GEORGETOWN-SCOTT COUNTY PLANNING COMMISSION

AGENDA

January 9, 2020

BLUEGRASS CAMPGROUND PRELIMINARY DEVELOPMENT PLAN

PRELIMINARY DEVELOPMENT PLAN
BLUEGRASS CAMPGROUND
269 CONNECTOR ROAD, GEORGETOWN, SCOTT COUNTY, KENTUCKY

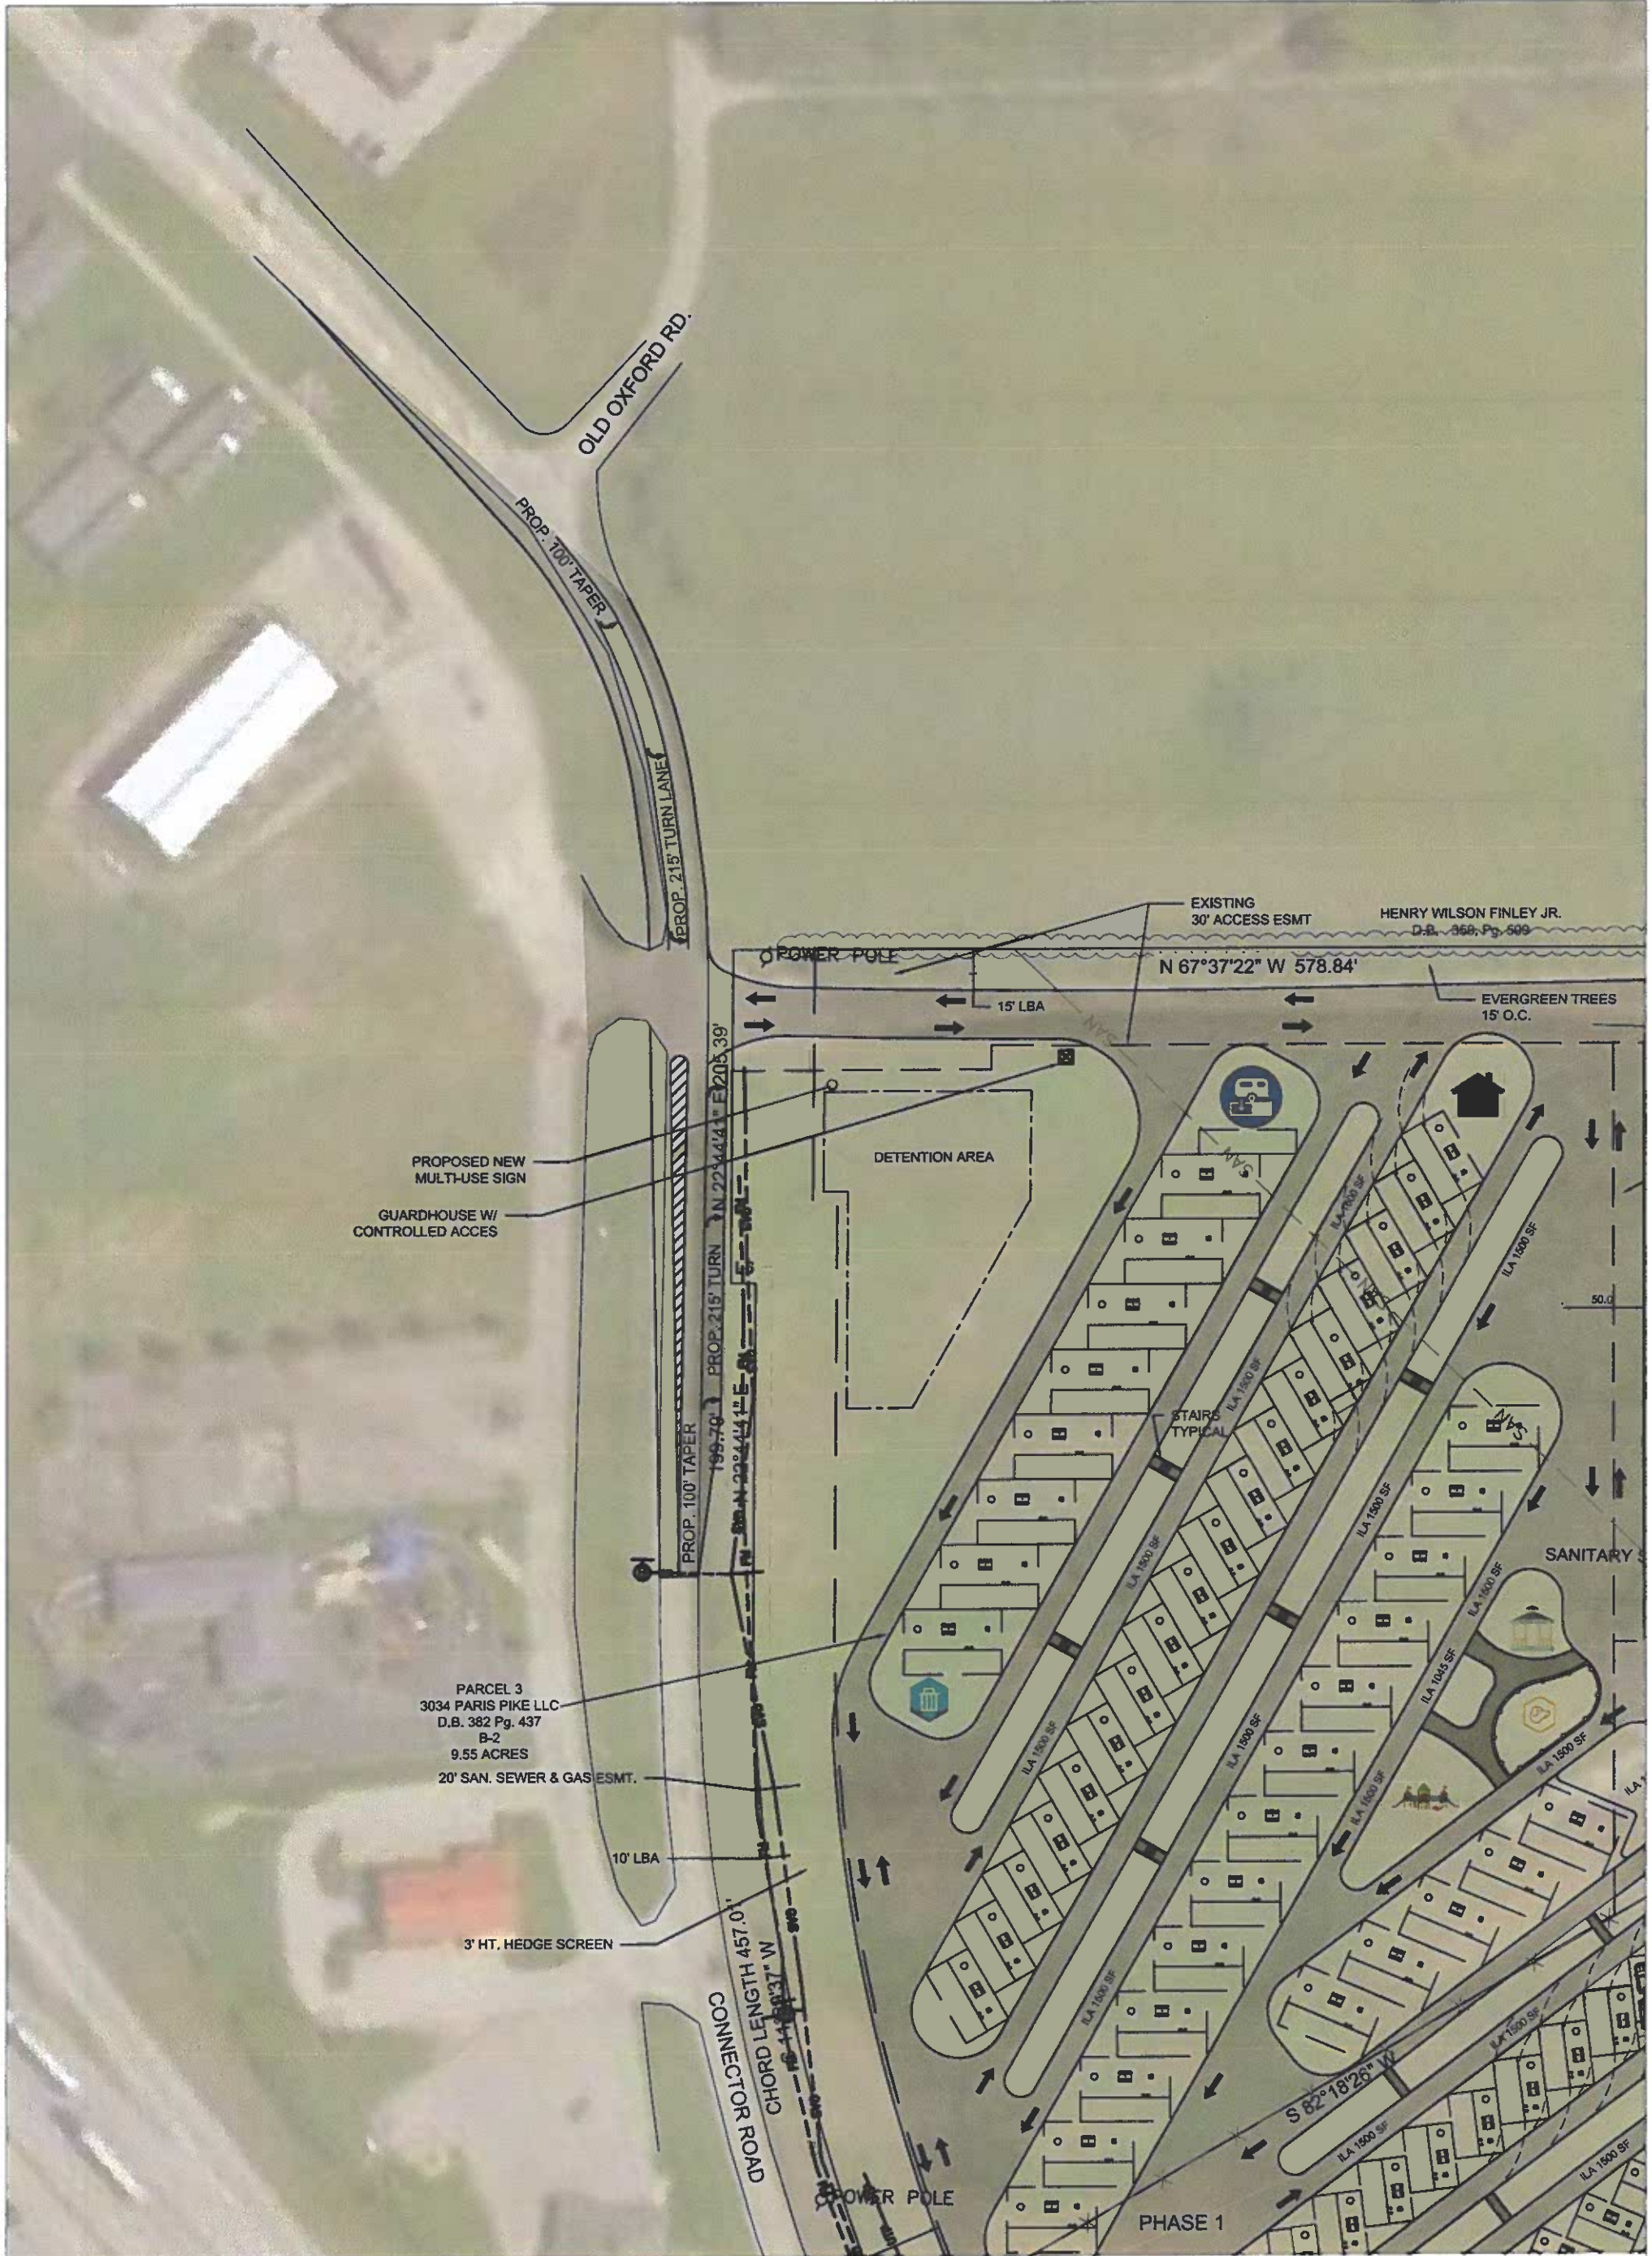
The development plan meets the setback, building height, and building coverage requirements of the *Zoning Ordinance*. The main difference between this development plan and the one submitted for review at the November Planning Commission meeting is the primary access to the site and the location of the check-in. The development plan shows the primary access to the site now coming along the eastern boundary. This layout will have a greater impact on the Rocky Creek neighborhood to the east. The previous version of the plan would have had relatively little impact on the adjoining neighborhood, while this layout will have about 80% of the traffic generated by the development driving along the backyards of the neighborhood.¹

The development plan proposing using gravel in the areas where RVs and cars brought in with those RVs will be parked for the camp sites. The use of gravel on a development plan requires approval of a waiver by the Planning Commission.

There are several inaccuracies staff found in the site statistics of the development plan. Many of these appear to be oversites and mistakes that can be corrected on the Final Development Plan. In the case of discrepancies, staff will treat counts of items like the number of RV camping sites in the staff report and conditions of approval as the officially approved numbers.

An access easement is proposed through the parking lot of phase 2 for access to the existing driveway along the eastern property line. This existing driveway has access to US 460 (Paris Pike). The Traffic Impact Study submitted by the Applicant indicates the US 460 entrance will be the primary entrance, and they have, accordingly, located the check-in building where it can serve this entrance. The Applicant should re-evaluate the phasing of the development to include the check-in building and access drive in the first phase of the development.

The Applicant submitted a Traffic Impact Study (TIS) along with corrections by the December 26th deadline. Staff has several concerns with the TIS including:

- It does not seem to account for trips generated by the dealership that will now be sharing a primary access point to US 460.
- It does not analyze the entrance of the campground/dealership on US 460 stating, "Analysis was not completed for the entrance on US 460 due to incomplete data from Scotland Drive." The TIS establishes that this will be the primary ingress/egress for RVs. It seems incomprehensible that a TIS for a proposed development would not have any analysis for the primary access where it has assigned 80% of the trips generated.

- The TIS does not have any analysis providing guidance regarding the best location for the primary access to the site. The TIS should have been a guide to the developer informing them and the Planning Commission about whether the entrance on US 460 or Connector Road was safer and more efficient. This was the primary question the Planning Commission wanted answered about this development.

There are challenges with providing pedestrian access to the Project Site. The Applicant is requesting a waiver to providing sidewalks along Connector Road. Staff supports this waiver, because of the topographical challenges present along the eastern side of Connector Road along the Project Site.

Phase 1 of the plan lists a VUA of 262,721 square feet which means 26,272 square feet of interior landscaped VUA are required with 106 trees planted in that area. The site statistics show 37,990 square feet of interior landscaped area with 116 trees, which meets the minimum requirements.

Phase 2 of the plan lists a VUA of 46,835 square feet which means 4,684 square feet of interior landscaped VUA are required with 19 trees planted in that area. The site statistics show 6,655 square feet of interior landscaped area with 35 trees, which meets the minimum requirements.

When the Bluegrass RV Dealership was proposed for development, it was approved by the Planning Commission for the first phase to be allowed to not meet the canopy requirements. The agreement was that when the area proposed for the second phase was developed, it would provide the remaining canopy coverage to bring the dealership into compliance. This is indicated by condition #6 of the conditions of approval from FDP-2017-05 which state, "Future development of the remainder of the Project Site shall bring the total canopy coverage of the Project Site up to 20%." This was a condition that was discussed when the Final Development Plan went before the Planning Commission and was signed off on by the Applicant at that meeting.

condition from FDP-2017-05 only applies to a future phase of the dealership, but the language in the condition specifically references the remainder of the Project Site. This was done because developers frequently change how future development areas are to be used. In order to meet the agreed upon condition, the Applicant will need to provide the necessary tree canopy on either the Phase 2 site (above and beyond the 24% required for Phase 2) for this application or provide the necessary canopy on the current RV dealership site.

At the November 2019 meeting, the Planning Commission requested the Applicant to look at the traffic generated by the development. The discussion at the time was whether there was a better entrance/exit to the site that could be used than the Connector Road entrance proposed at that time. The current iteration of the development proposes using an existing access point on US 460 (Paris Pike). However, staff has questions about how this choice was made. As discussed previously, the Traffic Impact Study explicitly states that it did not study this entrance. How can the Applicant know that switching the main access to the site from the Connector Road entrance to the Paris Pike entrance is a safer and more efficient choice? Looking at the current traffic counts from the TIS² for the two roads, shown in Table 1 (ADT, AM & PM Peaks), it appears the Connector Road entrance would be safer of the two due to its lower traffic volumes and fewer lanes to navigate for left turns, particularly if the proposed turn lanes are constructed on Connector Road. The Planning Commission continued this application in November telling the Applicant to investigate whether a different entrance location was better. The submitted Traffic Impact Study does not provide any analysis to answer the question that the Planning Commission continued the application for.

Staff recommends **continuing** the Preliminary Development Plan to a later meeting to allow the Applicant to analyze the two entrances and provide analysis on which location allows for safer, more efficient ingress/egress. If the Planning Commission approves the application, staff recommends the following waivers and conditions of approval:

1. Waiver to omit a sidewalk along Connector Road.
2. Waiver to allow the use of gravel for the RV/trailer parking areas.

7. All requirements of the Georgetown Fire Department.
8. The Applicant shall provide the additional tree canopy coverage to 20% in accordance with the dealership site to bring the dealership's tree canopy coverage to 20% in accordance with the Conditions of Approval for FDP-2017-05.

9. The Final Development Plans for each phase will need to independently comply with all requirements of the *Zoning Ordinance* and *Subdivision and Development Regulations* including the *Landscape and Land Use Buffers Ordinance*.

PRELIMINARY DEVELOPMENT PLAN

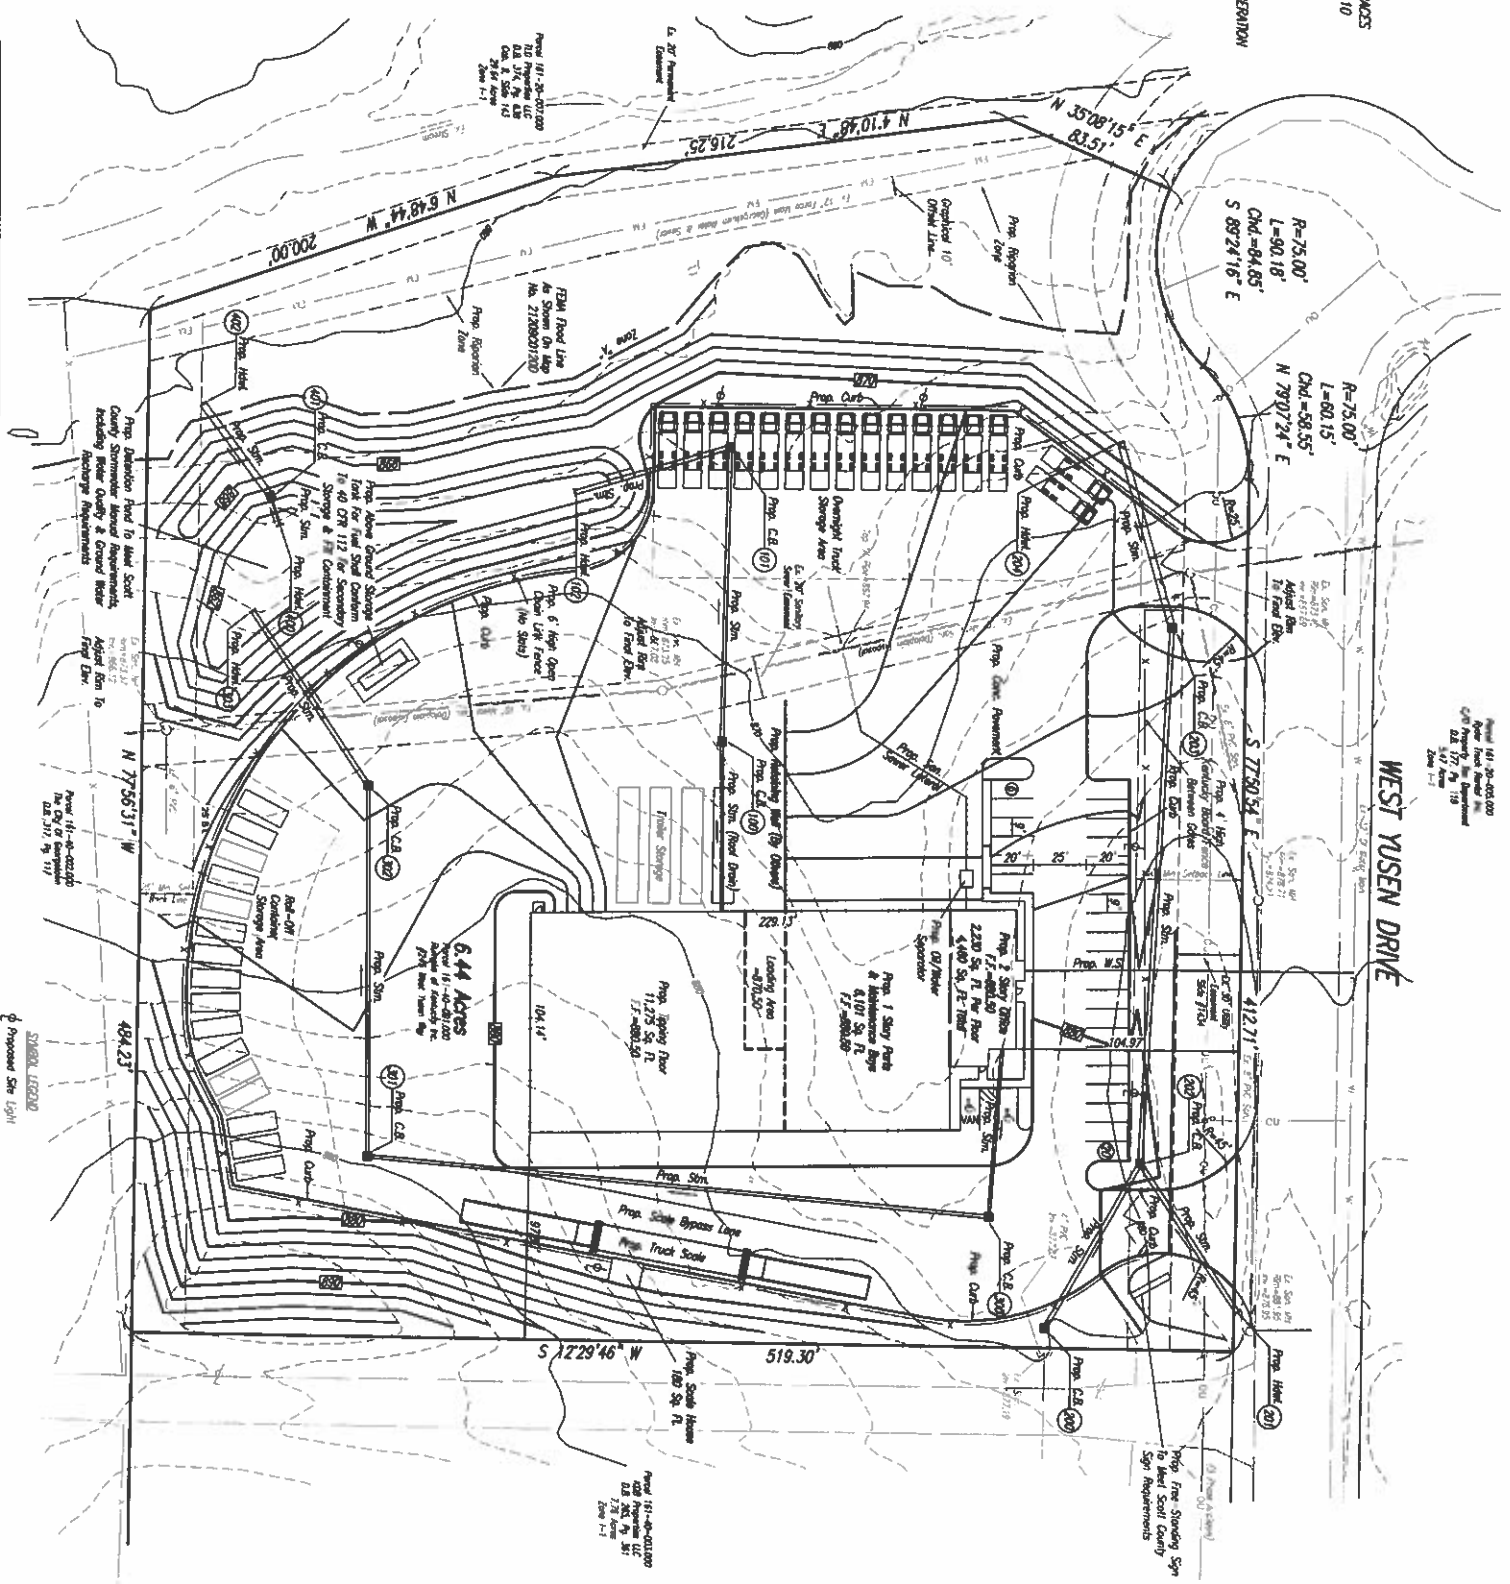
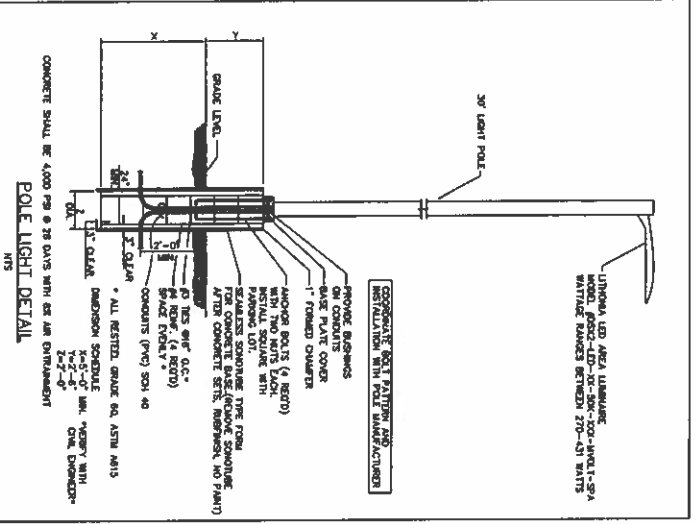
The submitted development plan shows one large approx. 105' x 230' building, which conforms to the setback, building coverage, and height requirements for the I-1 District. Employee and visitor parking is proposed in

Stormwater is proposed to be handled by a detention basin to be created southwest of the building and parking lot. The detention basin is proposed to be sized to handle the runoff from project site. There is floodplain on the lot, that is proposed to be left undisturbed. Some replanting of the floodplain is proposed according to the preliminary landscape plan in order to create a riparian area in the floodplain along Dry Run Creek.

The proposed access for the site is from West Yusen Drive via Triport Road and Cherry Blossom Way. These roads are existing public streets. The site is within ¼ mile of Interstate 75. The plan shows two entrances to the project site from West Yusen Drive. The eastern entrance will allow truck access to a truck scale on the east side of the building and will allow vehicle access to the parking lot at the front of the building. The western entrance will allow access to the overnight parking, maintenance bays and employee parking and will allow traffic to flow around the building and exit from the truck scales.

Vehicular Use Areas (VUAs) must be screened from public right-of-way. The development plan shows an appropriate amount of screening in front of the proposed VUA parking lot. While loading and unloading and storage areas are exempt from the screening requirements in the I-1 District, the automobile parking lots are not.

The Above Ground Fuel Storage Tank shall conform to state requirements for spill containment. Overnight storage of roll-off containers will require approval of the Scott County Board of Adjustment for outdoor storage and any conditions of approval from BOA shall be incorporated into the conditions of Development Plan approval.

Based on the findings above staff recommends **approval** of the Preliminary Development Plan with the following conditions:
